**STATE OF HAWAII
DEPARTMENT OF TRANSPORTATION
HIGHWAYS**

**ADDENDUM NO. 2
FOR
KUHIO HIGHWAY RESURFACING
WAIKAEA BRIDGE TO MAILIHUNA ROAD
FEDERAL-AID PROJECT NO. NH-056-1(063)
DISTRICT OF KAWAIHAU
ISLAND OF KAUAI
April 27, 2023**

This Addendum makes the following amendments to the Bid Documents:

**TYPICAL DETAIL FOR CONSTRUCTION SIGNS
 ON TWO LANE OR MULTILANE UNDIVIDED LOW SPEED HIGHWAY**

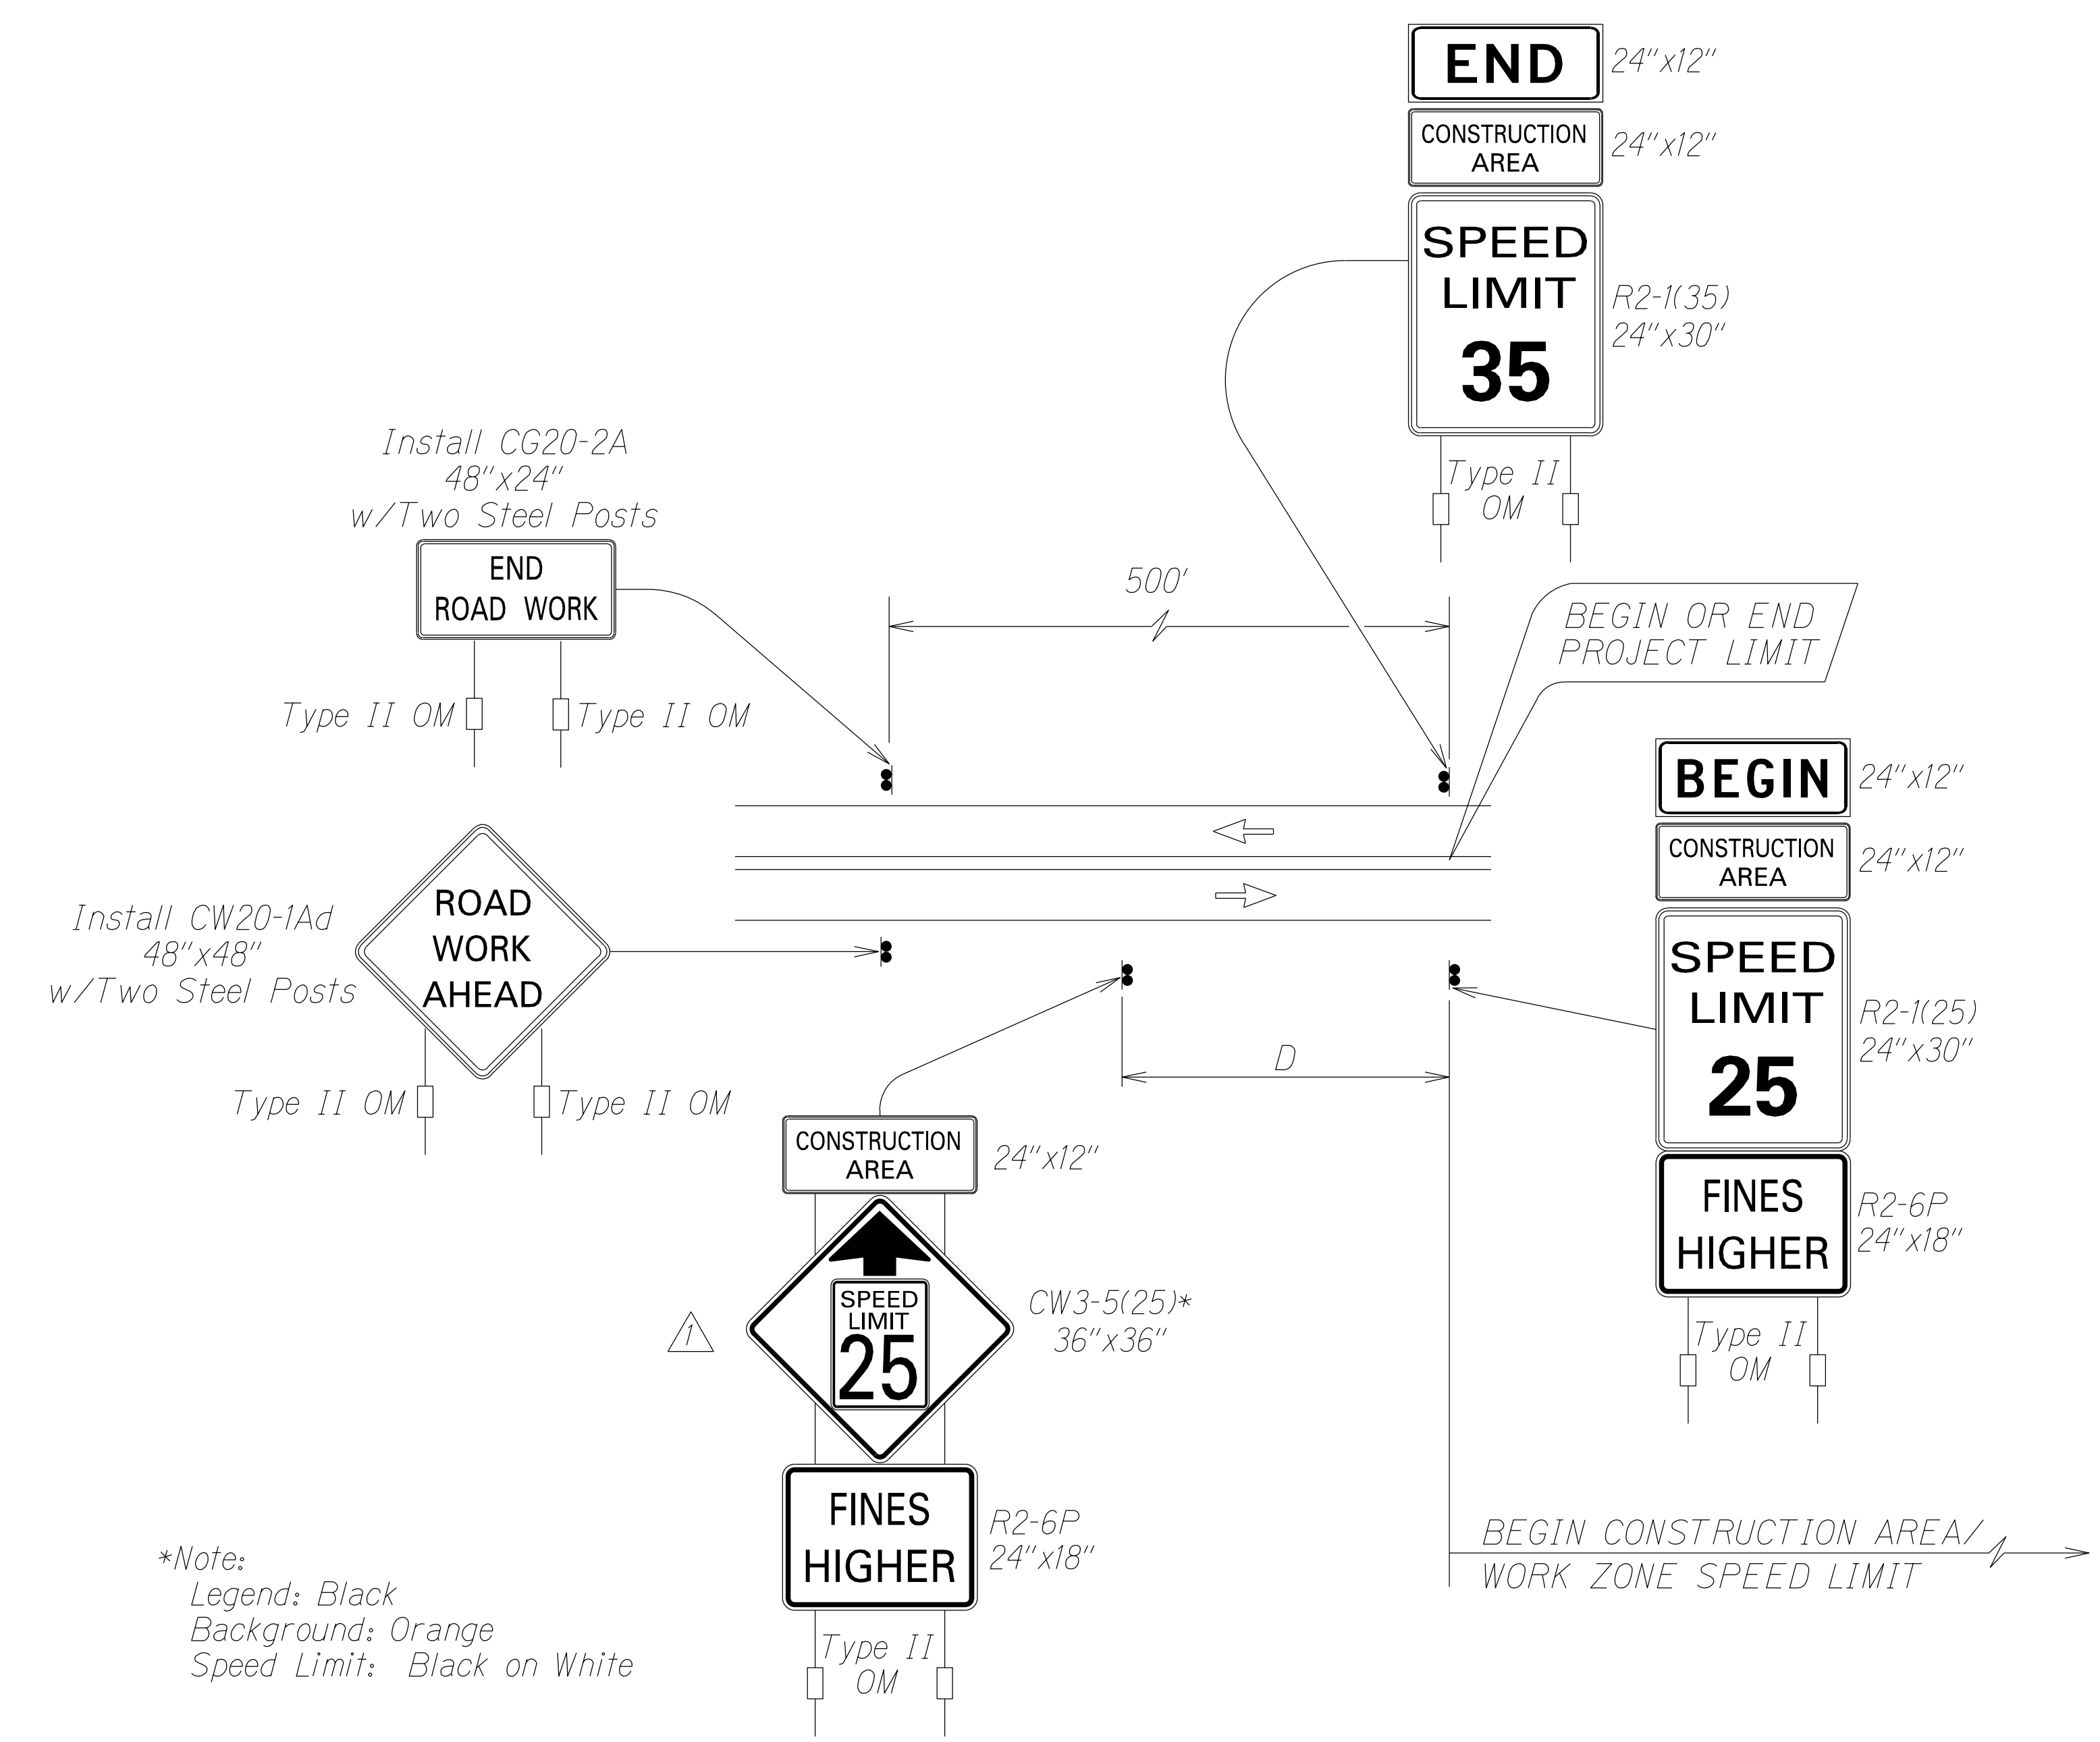
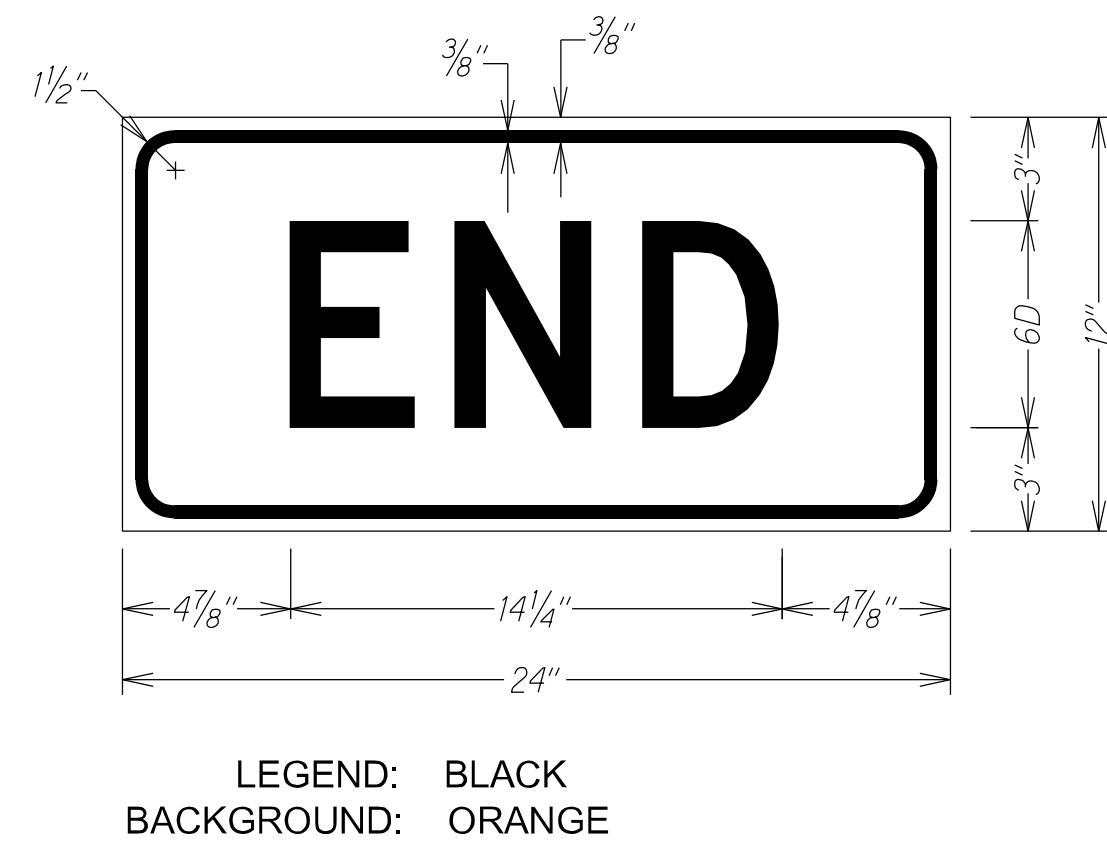
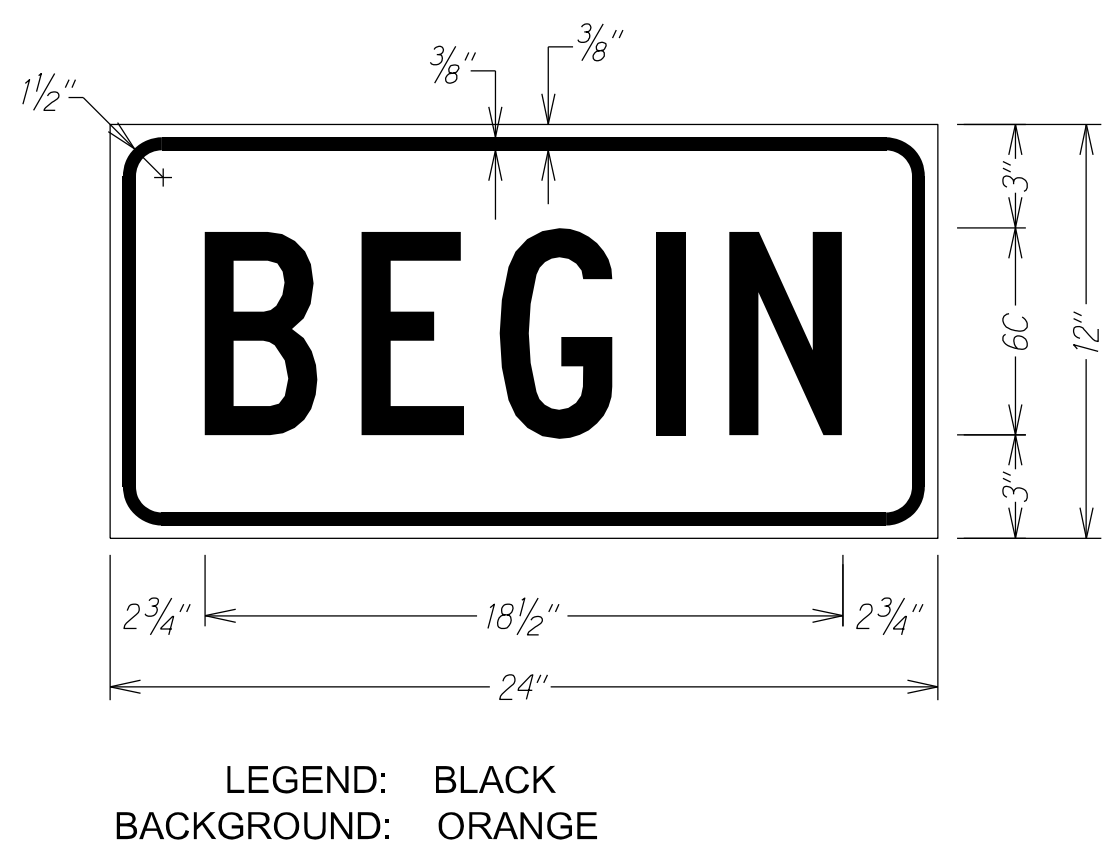
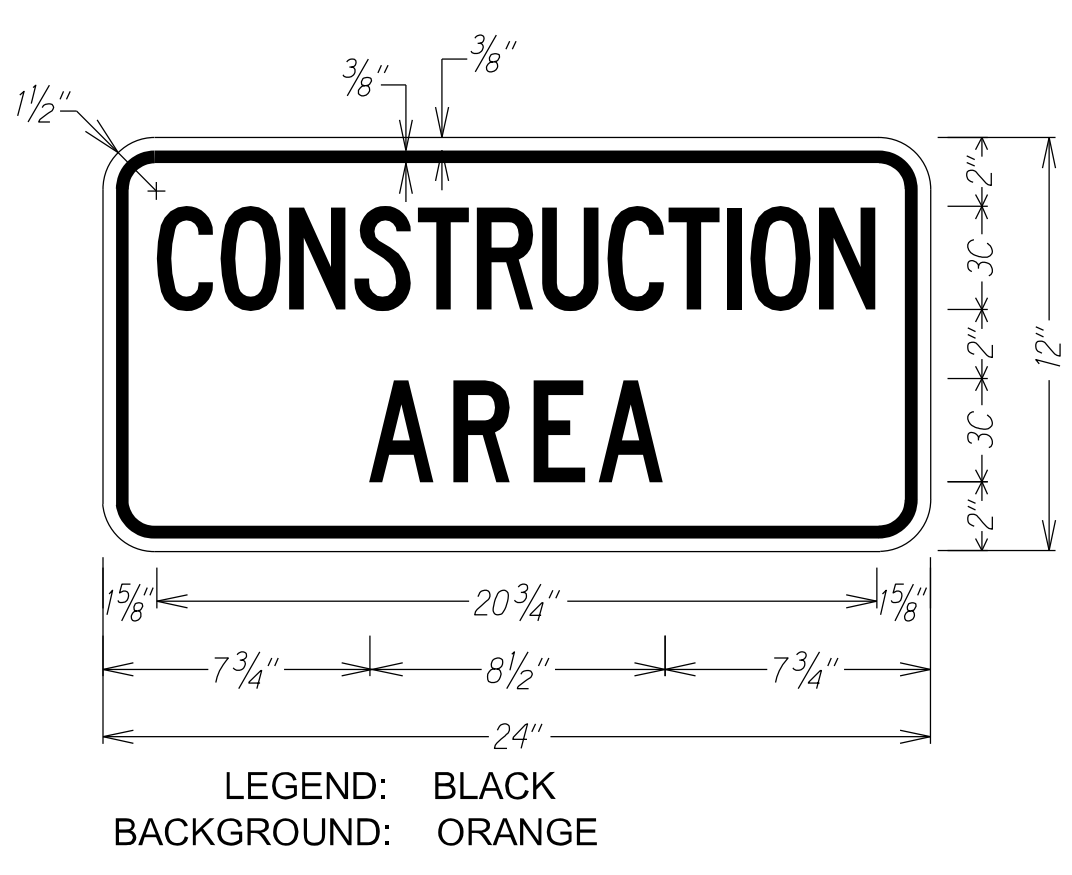
4/21/23	△ - Revise Typical Detail for Construction Signs
DATE	REVISION
STATE OF HAWAII DEPARTMENT OF TRANSPORTATION HIGHWAYS DIVISION	
LOW SPEED UNDIVIDED HIGHWAY	
WORK ZONE SIGNING PLAN, NOTES&DETAILS	
KUHIO HIGHWAY RESURFACING Waikaea Bridge to Mailihuna Road Federal-Aid Project No. NH-056-1(063)	
Not To Scale	Date: April 2023
SHEET No. 1 OF 1 SHEETS
